Working Party on the Transport of Perishable Foodstuffs

Proposals of amendments to ATP: new proposals

Restoring of the intended meaning of 6.2.2(ii)

Transmitted by the Government of Italy

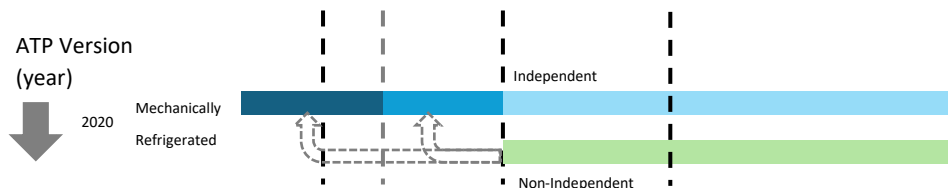
4. The ATP released in 2020 (and later versions) renumbered the paragraph as follows:

6. The change in the number of the paragraphs incidentally changed the meaning of the text by breaking the reference to the previous testing methods.

7. The wording “[...] the requirements of (i) or (ii) of this paragraph [...]” can be interpreted as referring to 6.2.2(i) and 6.2.2(ii) (making this reference circular) as “**this paragraph**” is now 6.2.2.

9. Amend 6.2.2(ii) to read as follows:

“For equipment constructed prior than 6 January 2018, this provision need not be applied. In this case the equipment shall comply with the requirements of **6.2.1(i)** or **6.2.1(ii)** as applicable for the date of construction.”
